PROJECT REFERENCE NO.	SHEET NO.
R-2514C	EC-7/CONST.7
RW SHEET NO.	
ROADWAY DESIGN ENGINEER	HYDRAULICS ENGINEER
 HDR Engineering, Inc. of the Carolinas 3733 National Drive, Suite 207 Raleigh, N.C. 27612 N.C.B.E.L.S. License Number: F-0116

CLEARING AND GRUBBING
EROSION CONTROL FOR
CONSTRUCTION SHEET 7

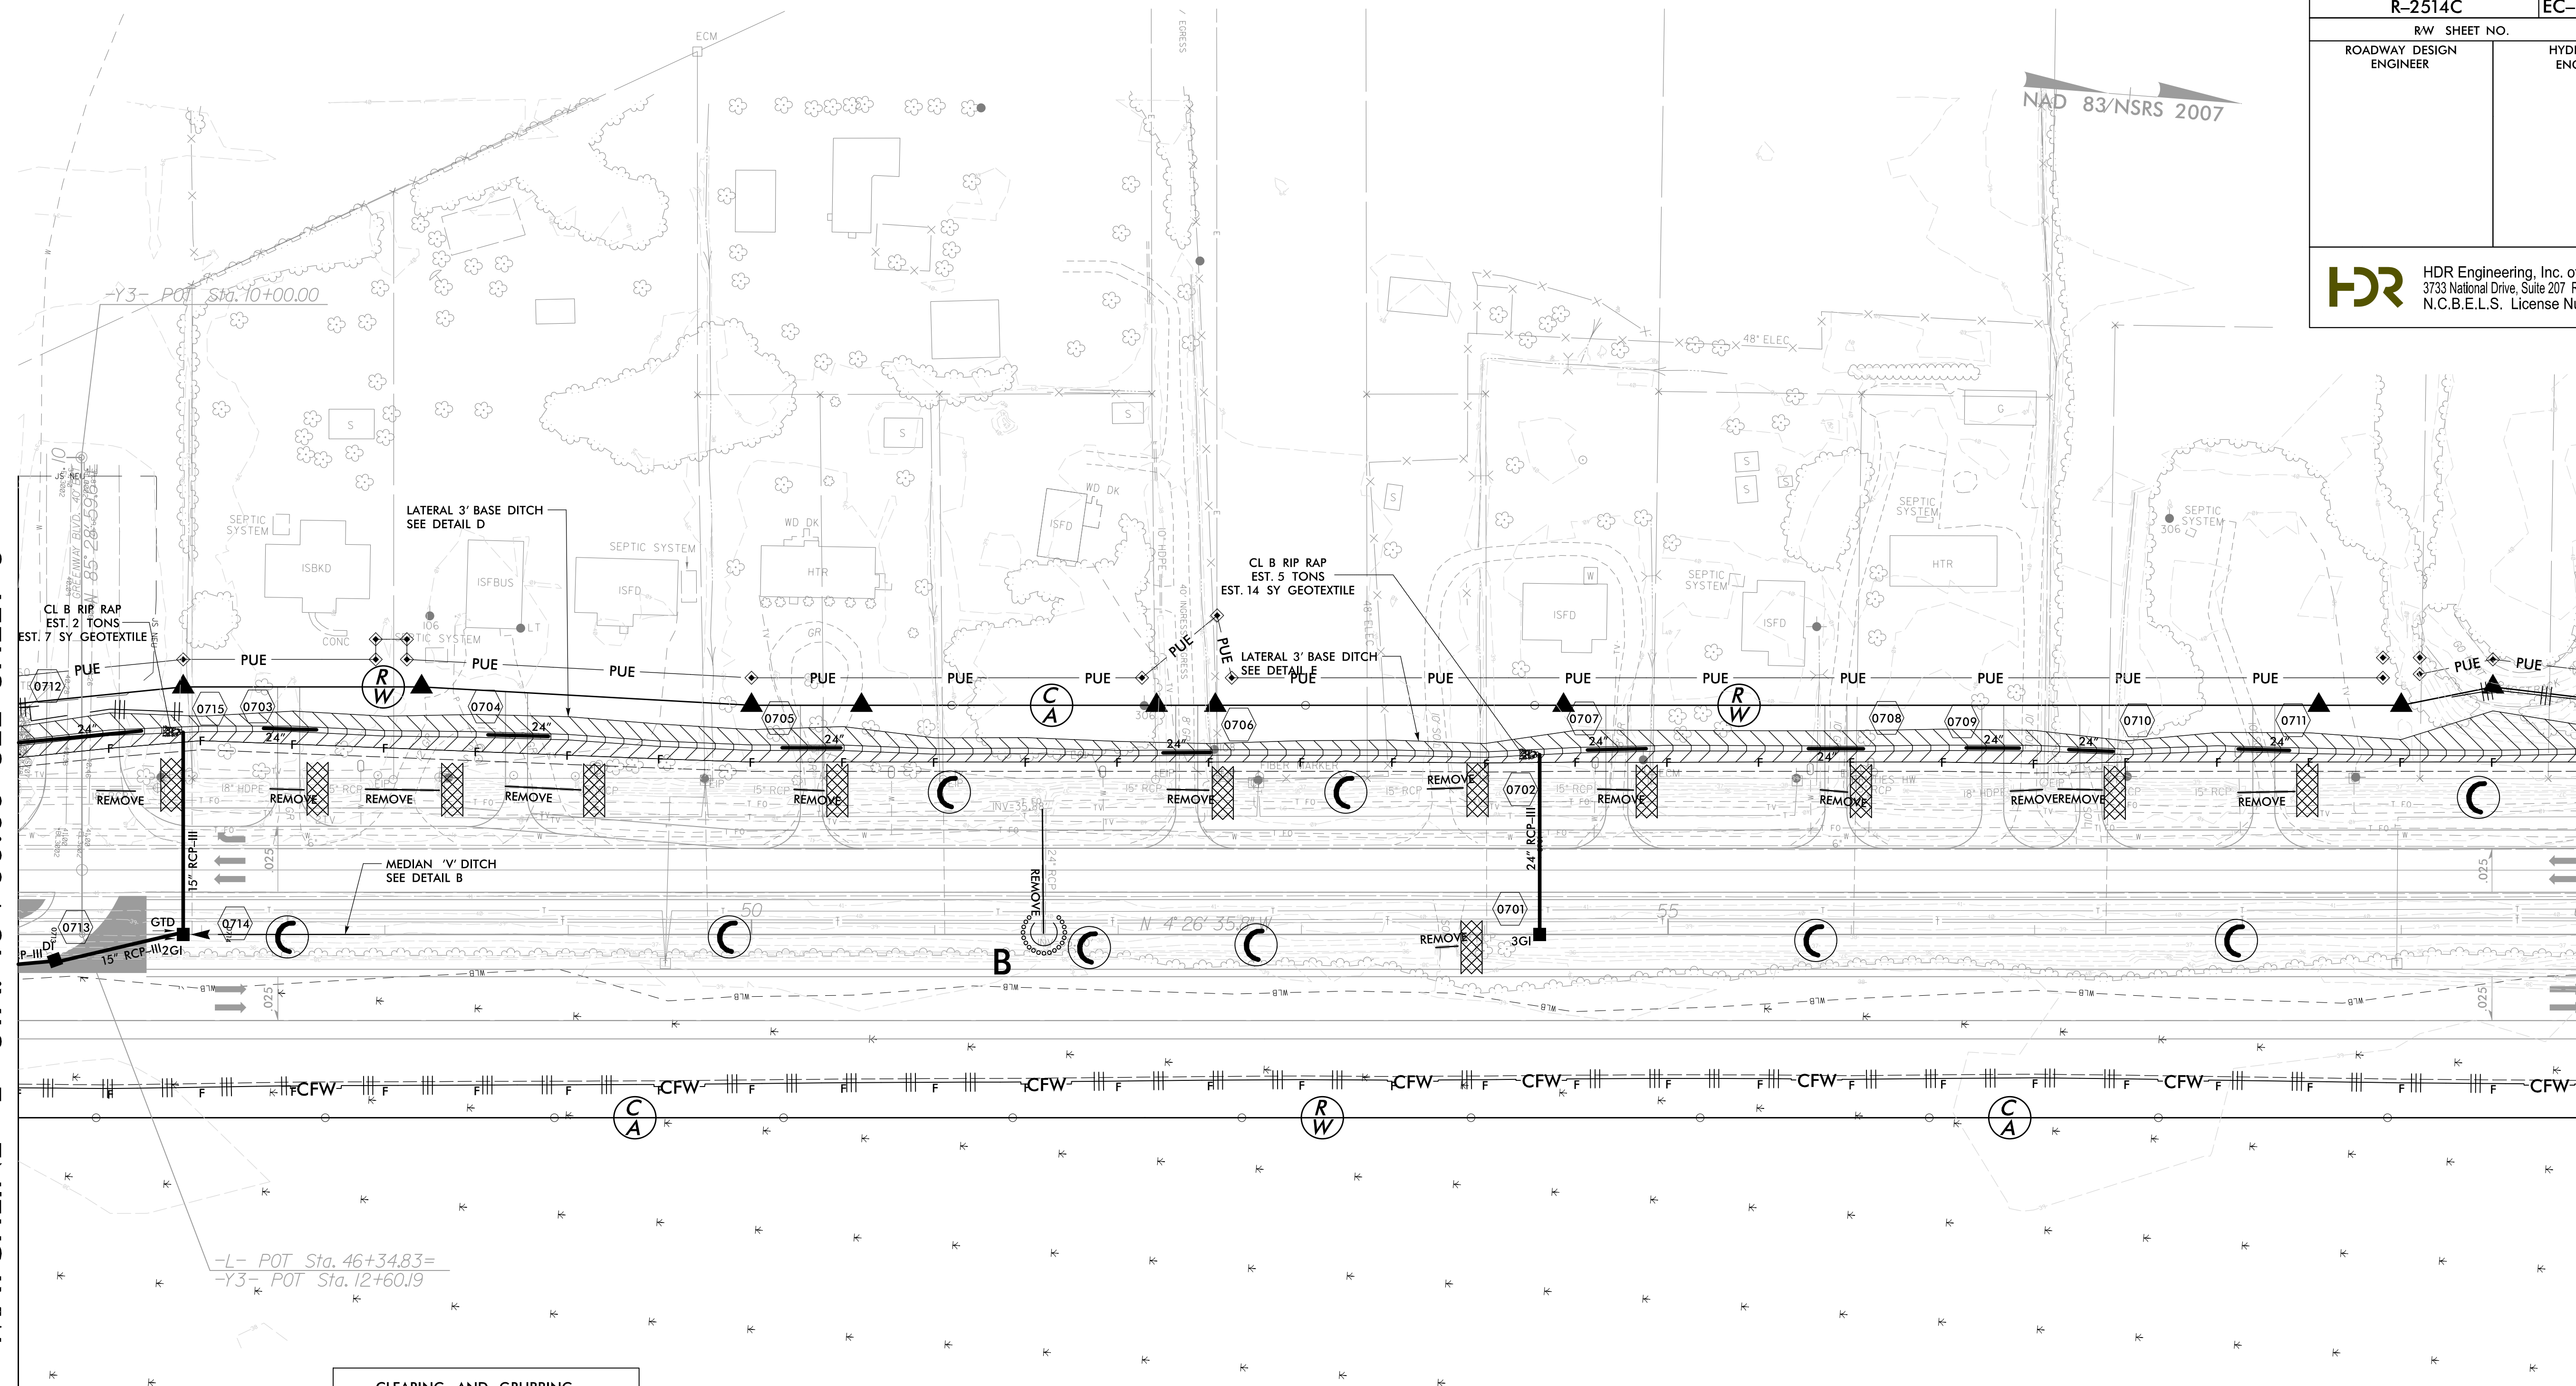
REVISIONS
 R/W REVISION 7-28-14 (DWG) - REVISED THE PROPERTY OWNER NAME OF PARCEL 21 (DORIS L HILL) TO PARCEL 21A (BRADLEY HILL). ADDED A SECOND CLAIM OF PUE ON PARCEL 21A (BRADLEY HILL), PARCEL 21Z (DORIS L. HILL), AND PARCEL 2BZ (RAYMOND C. BARKS, JR., ET UX).
 R/W REVISION 9-25-14 (DWG) - REVISED THE PUE ON PARCEL 21 (DORIS L. HILL). ELIMINATED THE SECOND CLAIMS (21Z AND 21AZ) FROM PARCEL 21 (DORIS L. HILL) AND PARCEL 21A (BRADLEY HILL).
